DRB RECOMMENDATION MEETING

4201 Stone Way N. Seattle, WA

SDCI PROJECT NO.:
3019441

MEETING DATE:
02/27/2017

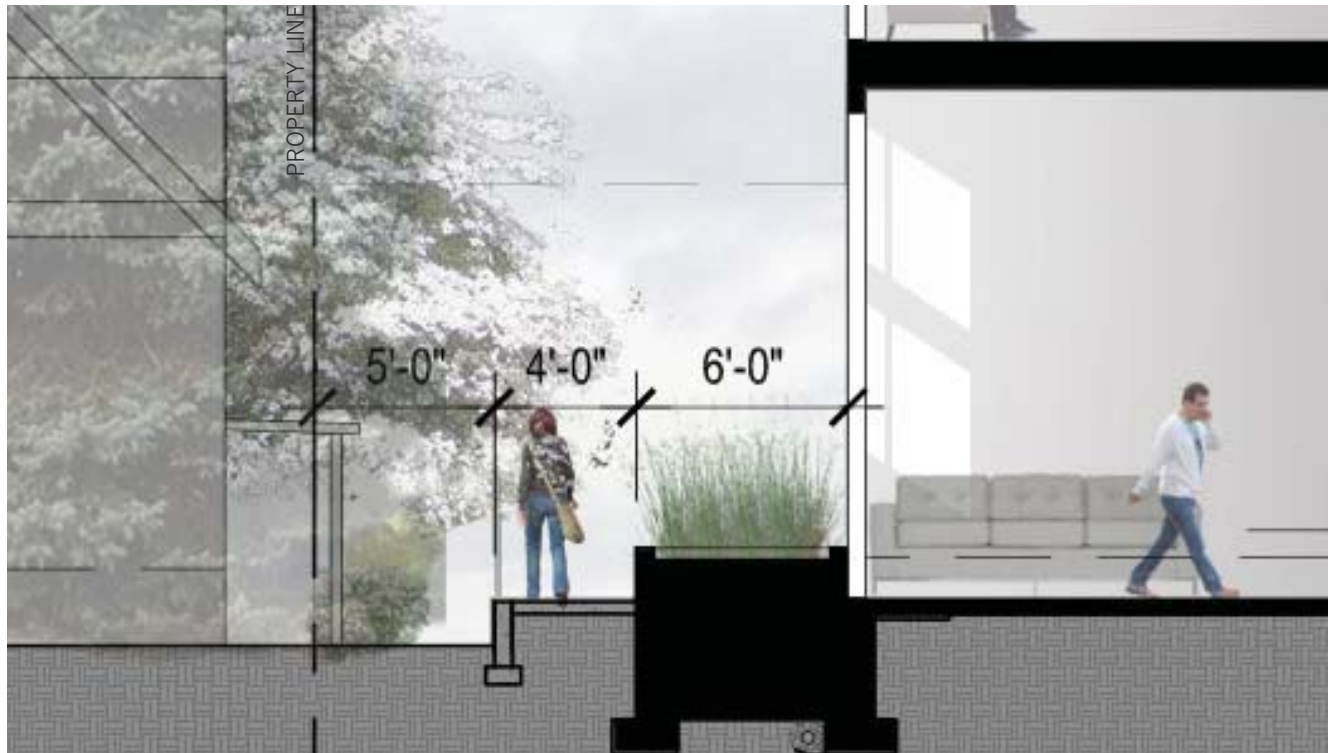
1.b. Board members discussed at length the possibility of increasing the building setback from the adjacent residential property. One board member suggested the possibility of increasing the setback in light of the west facing units being fairly deep. However other board members felt that the proposed design met the intent of code with all three eventually agreeing that the proposed west setback was acceptable (CS2-B, DC1-A).

1.c. An individual board member discussed the possibility of increasing the modulation of the western building facade as a means of breaking up the visible mass of the wall. In the end the applicant team was not directed to make any additional revision to the West facing building facade. (CS2-B, CS2-D, DC2-A, DC2-B).

Architect Response:
No additional setback is required to the westerly facade of the proposed design.

Architect Response:
No additional modulation is required to the westerly facade of the proposed design.

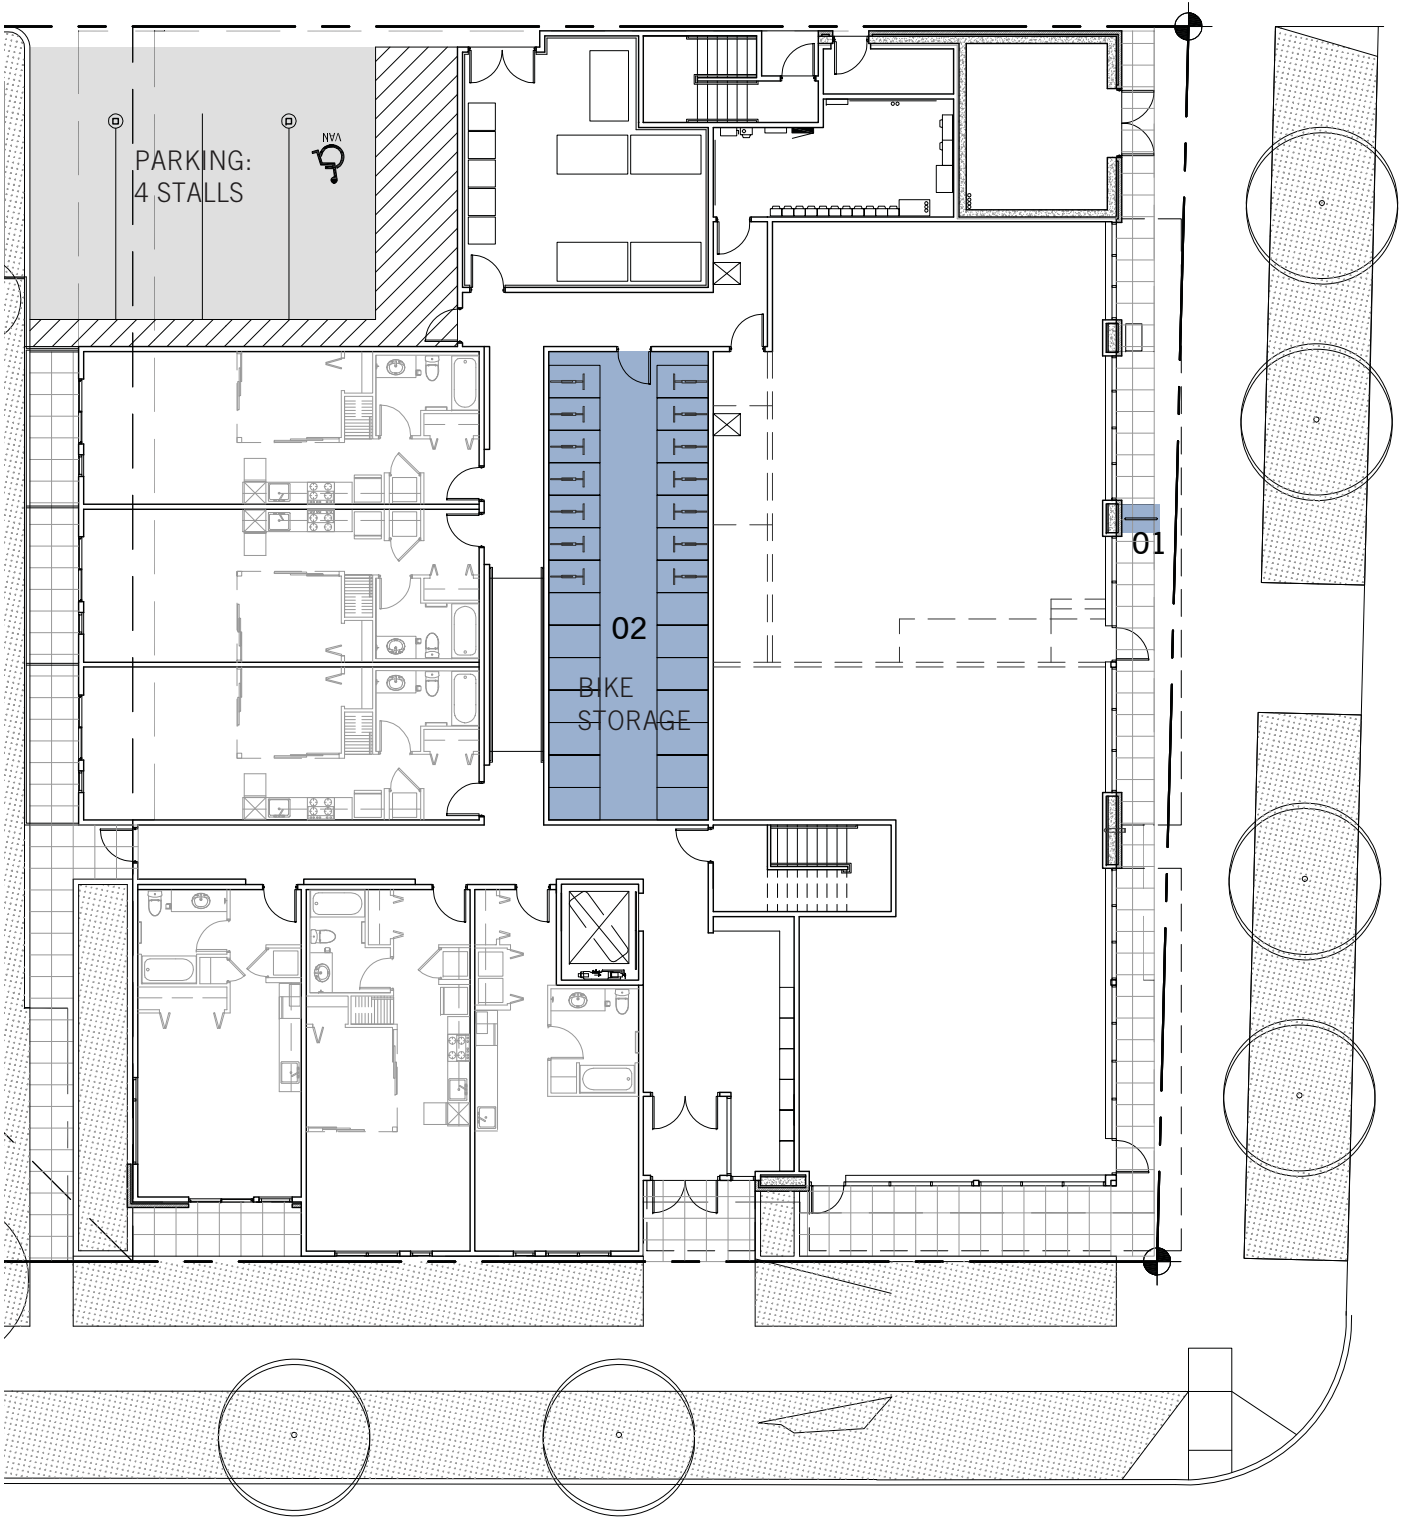
4.a The Board suggested that the small amount of parking being provided should be considered in combination with a ride share or car share program and bike parking. (DC1-C, DC1-I)

4.b. The Board also wanted to see more detail about bike parking and storage space identified.

Architect Response:
4 parking stalls off the alley have been incorporated into the design. Bicycle parking has been provided per land use code requirements.

Architect Response:
Spec sheets of the bicycle parking lockers will be identified in our DRB package.

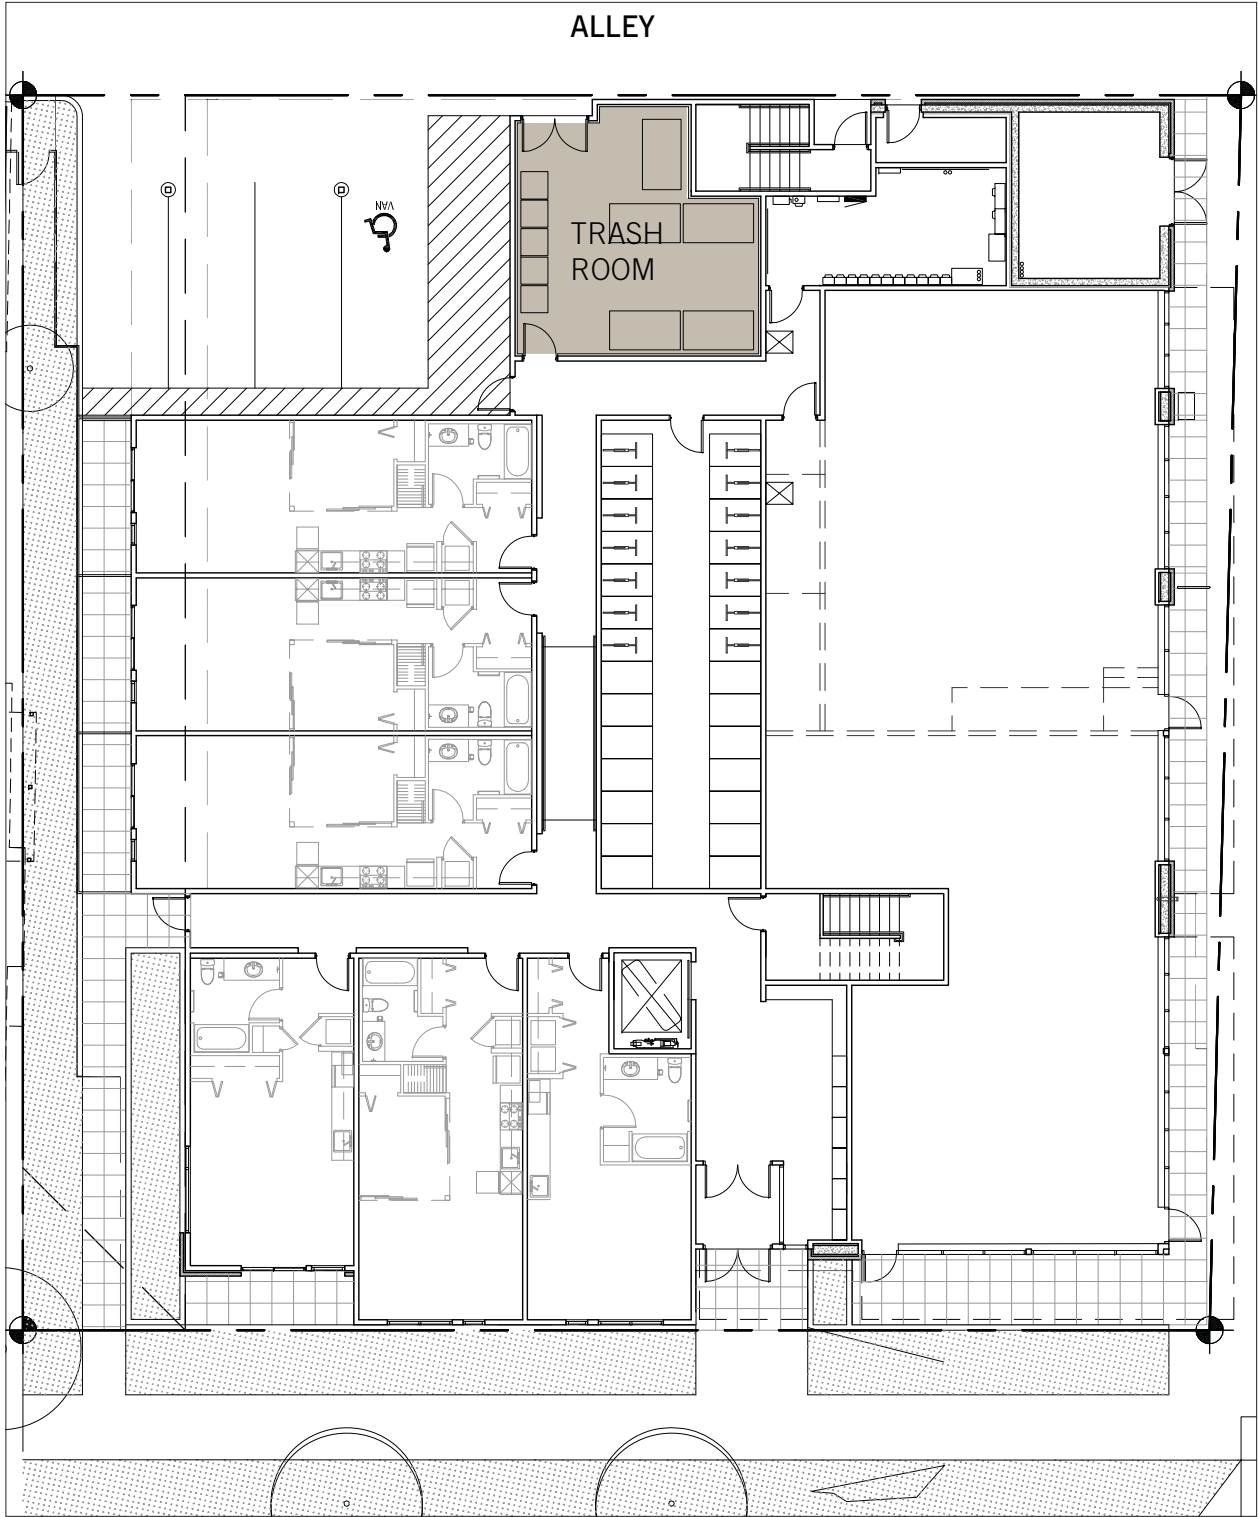
5.a The Board was concerned with possible impacts from odors and noise and therefore felt that trash should be moved or relocated to a different location or enclosed and ventilated in order to respect the adjacent residence to the west. (DC1-C.4)

The trash and recycle is now fully enclosed and has been move to the east, away from the single family zoned lot.

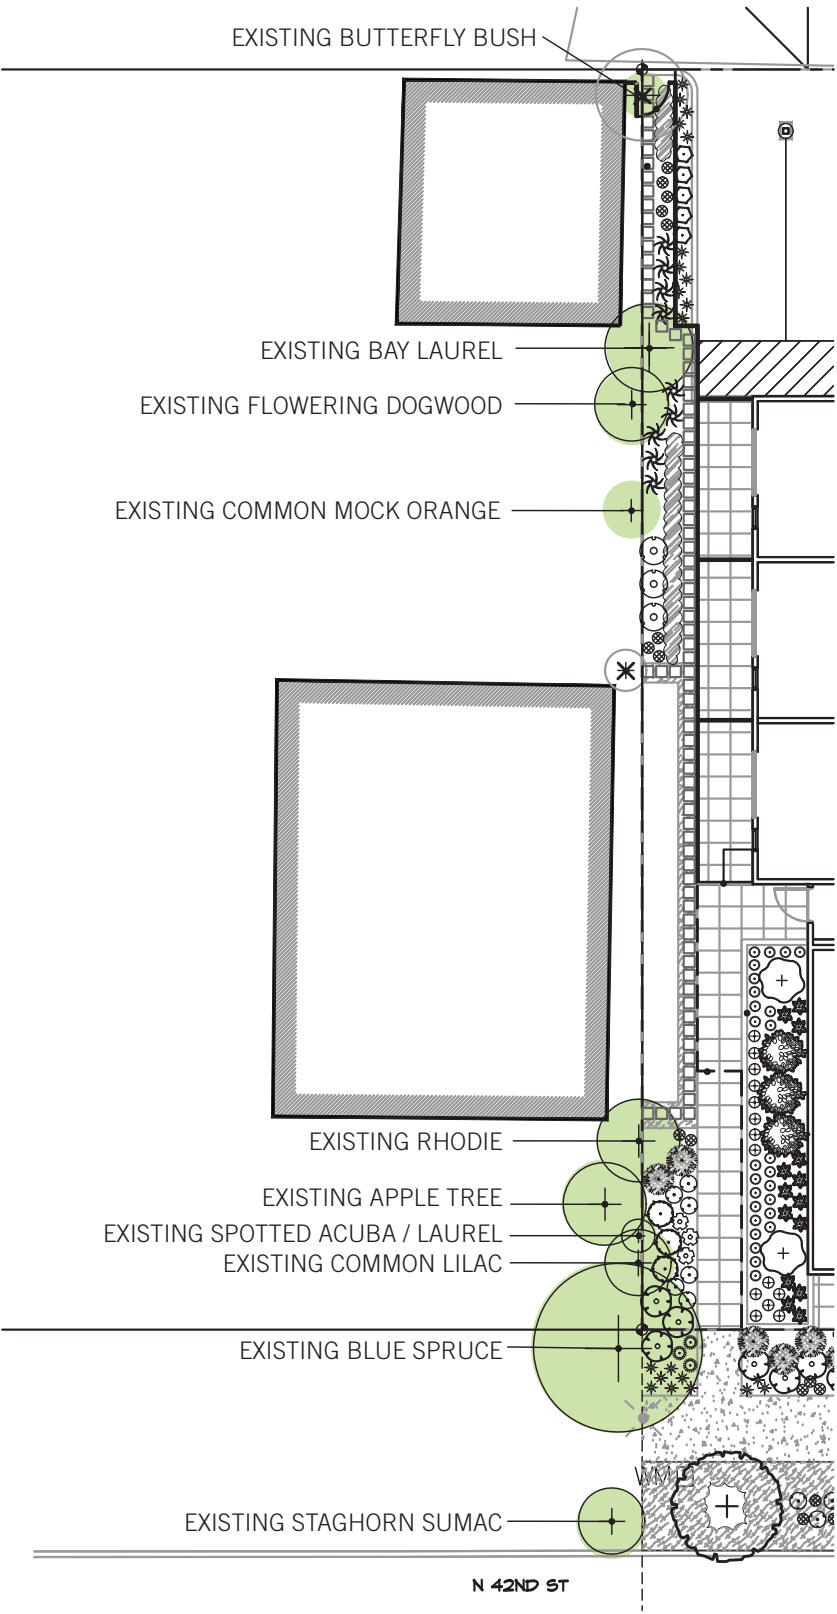
6.a While not exceptional, the Board directed the applicant to develop a scheme for preserving the trees on the adjacent residential property to the west. (PL3-B, DC4-D, DC4-1, DC-4-II)

Trees and shrubs on the westerly line abutting the residential zone are to remain undisturbed.
